REQUEST FOR PROPOSALS

Elmsdale Business Park Engineering
RFP50187 - Addendum 1

Release date: June 26, 2018

SHEET NO.
3

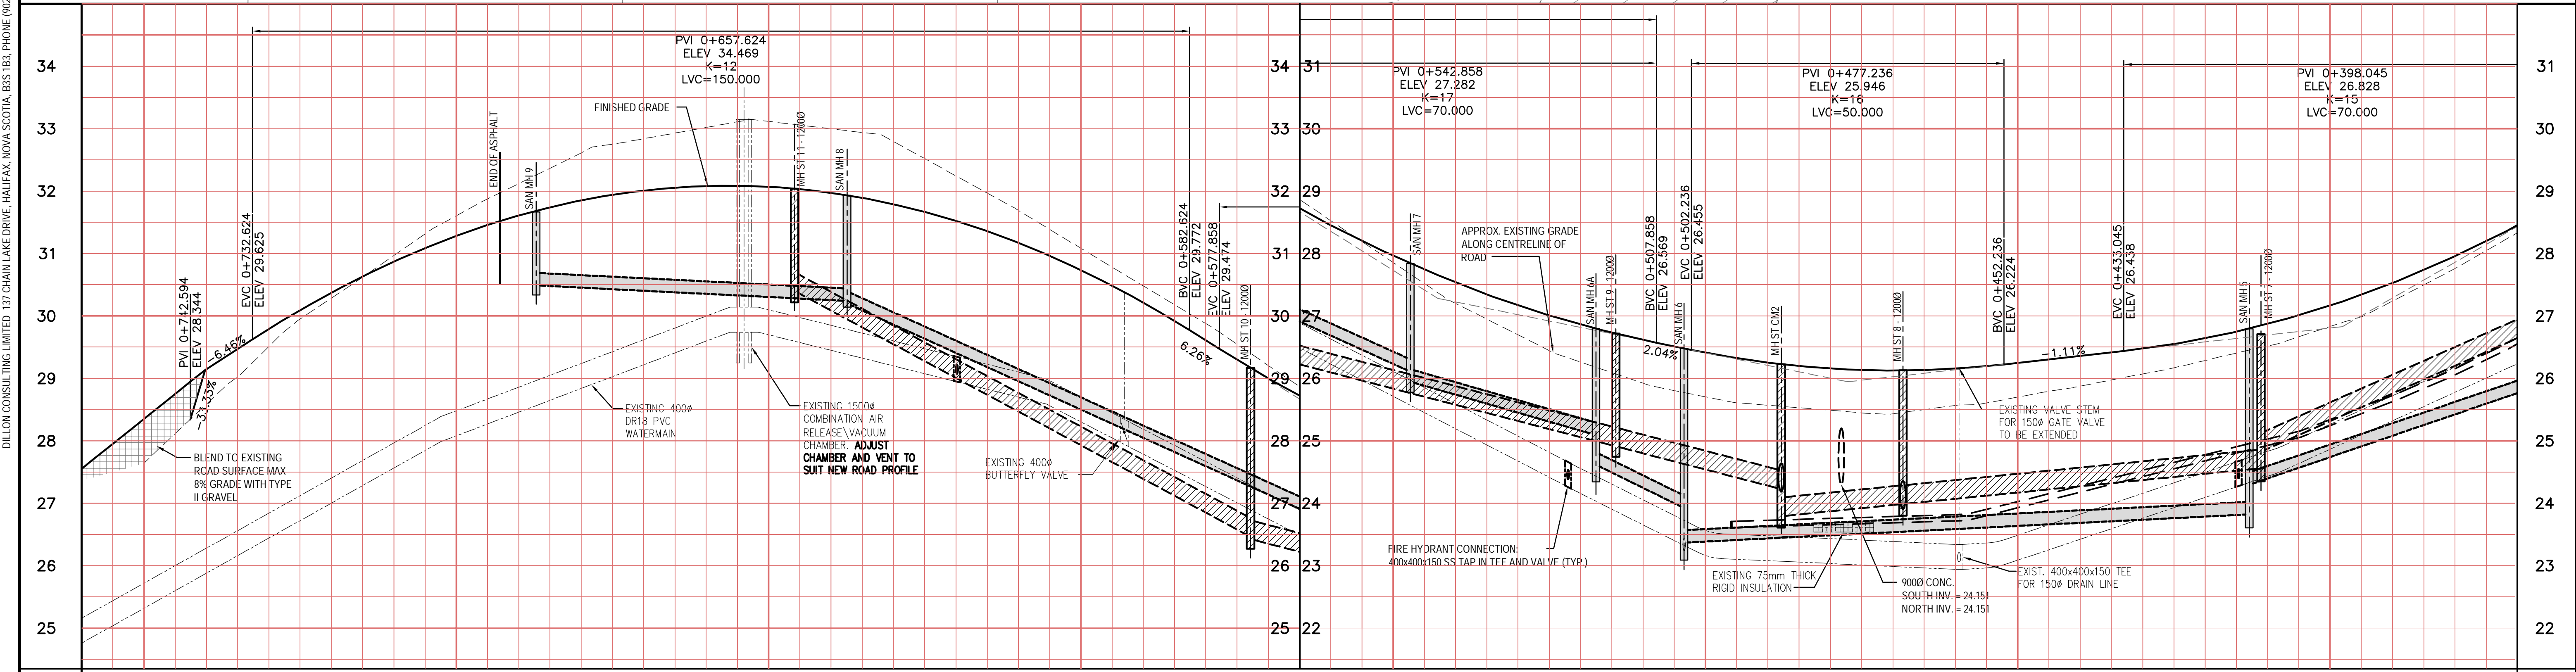
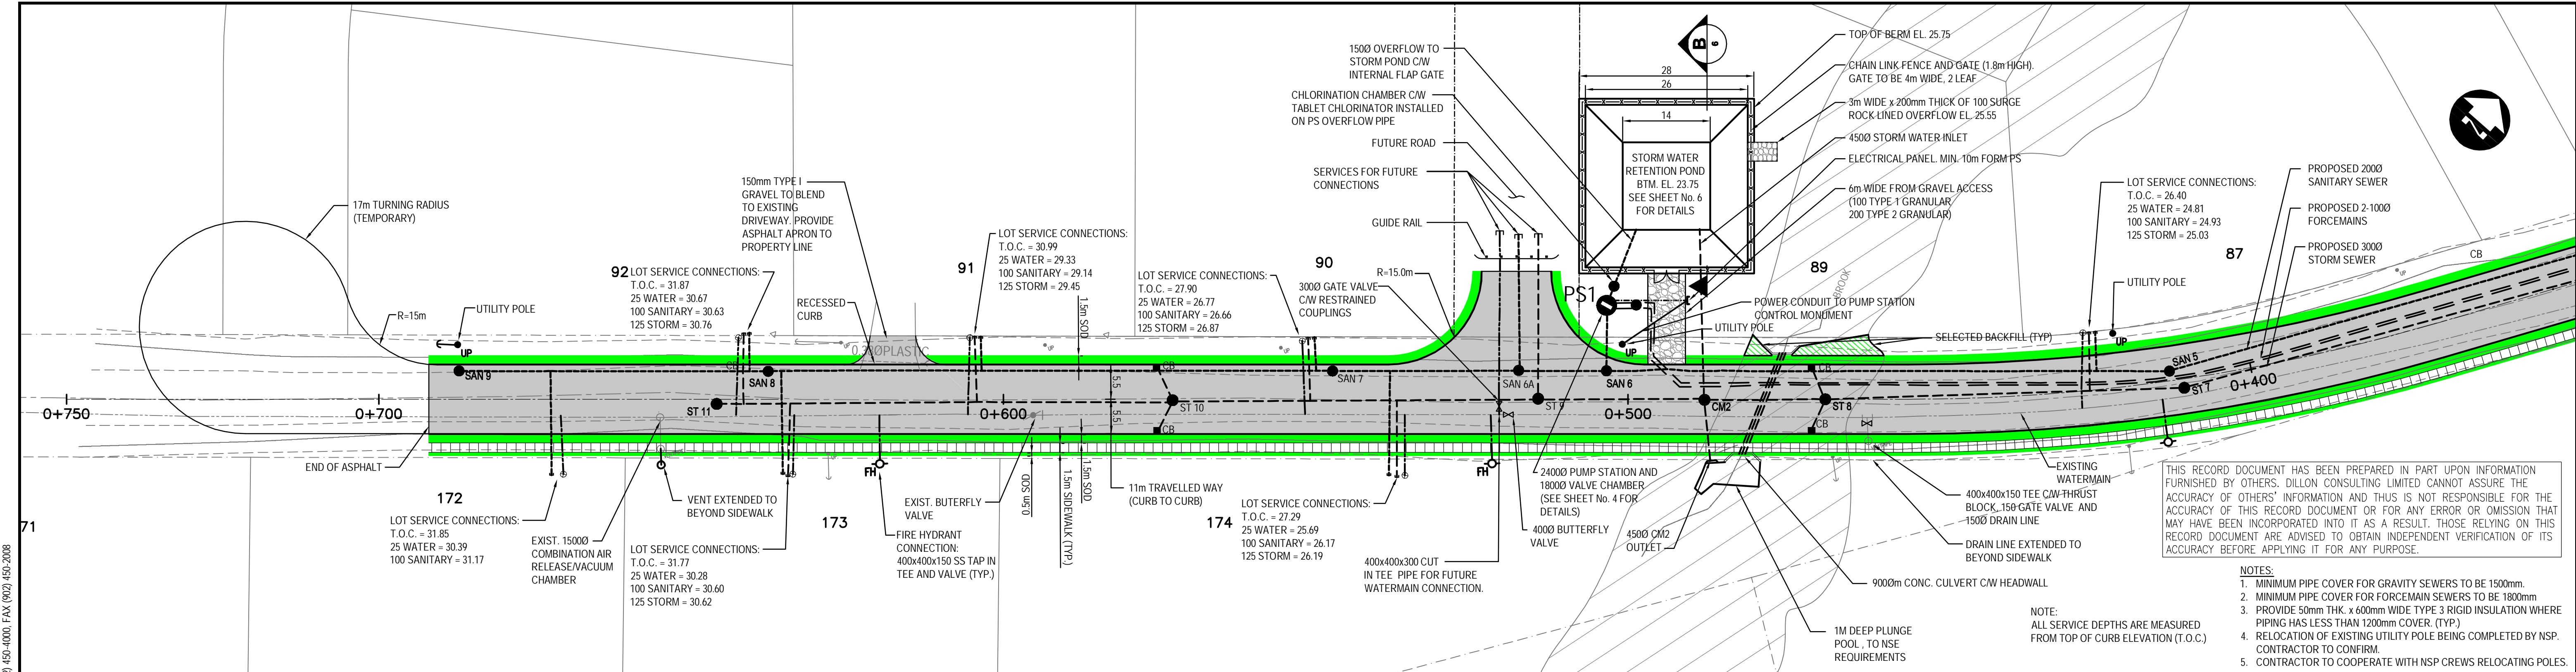
In section 2.4 - 2.4.1, it says “It is anticipated that the sanitary sewer will drain by gravity to the existing lift station on Park Road. Does this mean the service from all three roadways needs to empty directly into the lift station, or can the sanitary on Street “H” tie into the existing sanitary system on Park Road?

Answer - This wording is intended to convey that no new lift stations are to be included within this design. The proposed sanitary system can tie into the existing sanitary system. Dillon Consulting drawing 12-6080 - sheet 3 is attached to provide information on the existing services in Park Road.
